DOCUMENT CHANGE REQUEST

DCR number 272 Changes required for: General

Title: Diodes, Silicon, Power Rectifier , High Efficiency, Fast Recovery, based on type BYW81-200

Number: 5103/029

1.7.2 Surface Mount Package (SMD.5) - 3 terminal

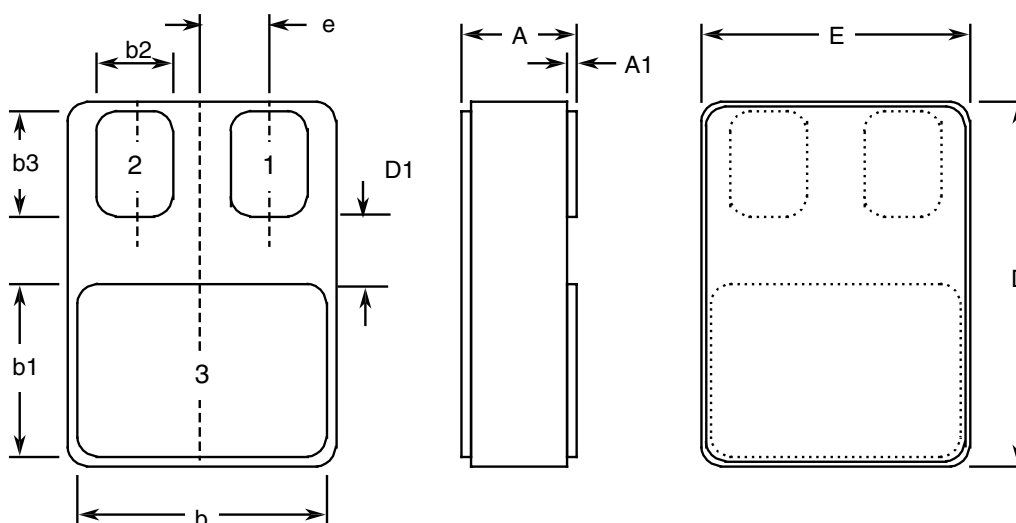
1. Rewording and restructure of various sections and paragraphs of the specification plus other editorial changes based on the layout and editorial content of other Detail Specifications already converted to ESCC format.
2. Deletion of any redundant paragraphs and information, e.g. the mechanical paragraph.
3. Table 1(a) . Lead material and Finish corrected from .P14. to .Q14. for Variant 05.(was typo)
4. Figure 1 Parameter Derating Requirements - moved to be a note to the Maximum Ratings table.
5. New paragraph for Beryllium Oxide handling precautions added for type variants with the TO-245 package.
6. Figure 2(a) - Dimensions .H., .J. and .K. corrected from "Typical" to "BSC". Dimension .I. corrected to .fl. and .M. to .fM..
7. Figure 2(b) . New drawing added to harmonise this SMD.5 package outline with all other ESCC specifications with this
